<b>SAFETY ALERT</b>	
	<b>Flight Design GmbH</b> Sielminger Str. 65 D-70771 L.-Echterdingen Tel +49 (0)711 90287-0 Fax +49 (0)711 90287-99 E-Mail: <a href="mailto:info@flightdesign.com">info@flightdesign.com</a>	<b>SA-ASTM-CTSW-02</b> <b>Revision 0</b>
	Date of Initial Publication: <b>15-Oct-2008</b> Publication Date of this Revision: <b>15-Oct-2008</b>

## Servo Tab Spring

## FLIGHT DESIGN USA SAFETY DIRECTIVE No.14

Fig. B Location of the Servo Tab Spring as illustrated in the Modification document.

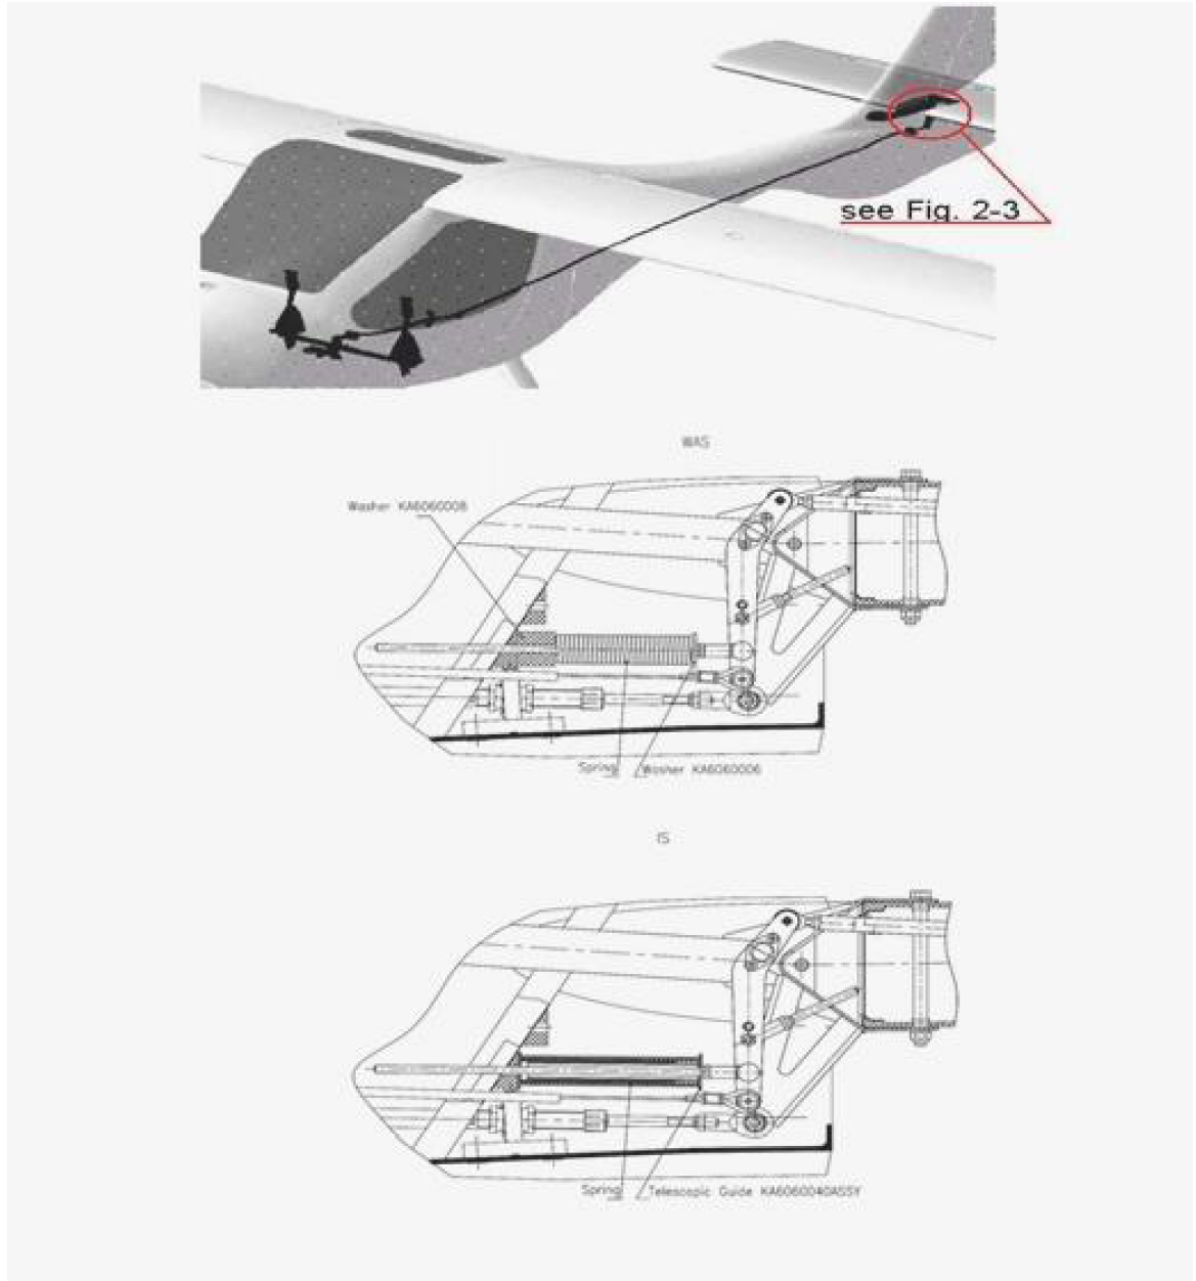
Flight Design is mandating a modification of the trim system on the affected aircraft that consists of replacing the original spring and associated spacer and washer with a new spring and telescopic spring guide assembly.

- A. The new spring is longer than the original (37 windings instead of 35 windings). The original is too short and must not be used.
  - B. The movement of the original, shorter spring is limited at one end by a plastic spacer (KA6060008) and at the other end by a washer (KA6060006). These are also not re-used.
  - C. During assembly, the gliding surfaces of the telescopic parts must be lubricated by use of Aeroshell Grease 6 or equivalent.
3. Mount the stabilizer in accordance with the Maintenance Manual and check for correct operation.
  4. Tag the original spring with the aircraft serial number and return to Flight Design USA.

1. Remove the stabilizer from the airplane according to the maintenance manual.
2. Perform the maintenance procedure "Trim Tab Spring Modification CTSW2006" dated 13-10-2006.
